PLANNING AND ZONING BOARD STAFF REPORT

Delray Swan

Meeting	File No.	Application Type
November 27, 2023	2022-063-SPF-SPR-CL5	Level 4 Site Plan with CBD Waivers
Property Owner		Agent
Clifford Rosen, SM-CDR Assemblage Delray, LLC		Neil Schiller, Esq., Government Law Group and Jeff Costello, AICP, JC Planning Solutions

Provide a recommendation to the City Commission for a Level 4 Site Plan, Landscape Plan, and Architectural Elevations for the construction of a +/-304,506 square foot, five-story mixed-use building known as Delray Swan, including a revitalization incentive density bonus of up to 70 dwelling units per acre.

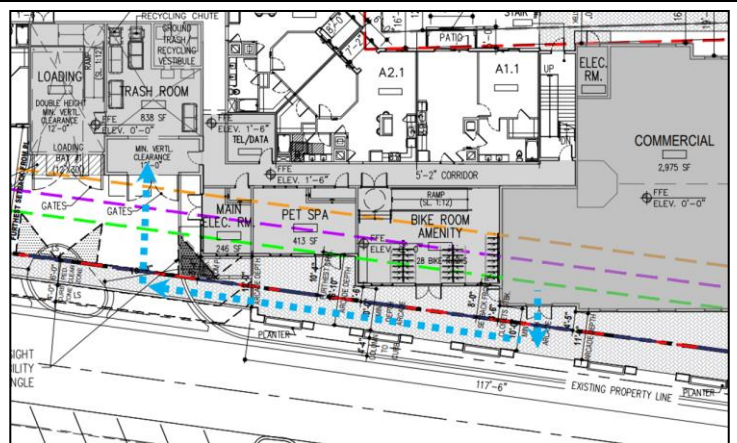
However, there are significant concerns as to whether the proposed development offers a sufficient strategy for functionally appropriate trash disposal. A sufficient number of trash containers are proposed, but they are not adequately accessible by tenants of the commercial bays. Specifically, there is no logical connection between the sole trash room provided on site and the commercial bay. There is no feasible connection for employees of the commercial bay tenant to dispose of waste in the trash room without navigating the trash out through the primary storefront entrance of the commercial bay, through the public sidewalk under the arcade,

off-site into public right of way, back on site further down the block, and finally into the designated trash room (image at right). It is also important to note that there is no pedestrian door or access point from the exterior into the trash room. This route to the trash room via the public sidewalk will create an opportunity for waste to leak during transit and negatively impact the smell and appearance of the public realm with remnants of commercial waste. This is not an acceptable solution in the opinion of staff. This is a conflict, because this element of the proposed use does not have a viable means to accommodate a vital aspect of functional site design. There is no public benefit (and a potential detriment) to the proposed trash disposal strategy; alternative solutions exist. Staff recommended that an interior door be provided to allow waste to be transported from the commercial bay to the trash room via the interior corridor, thereby mitigating the adverse impacts on public space.
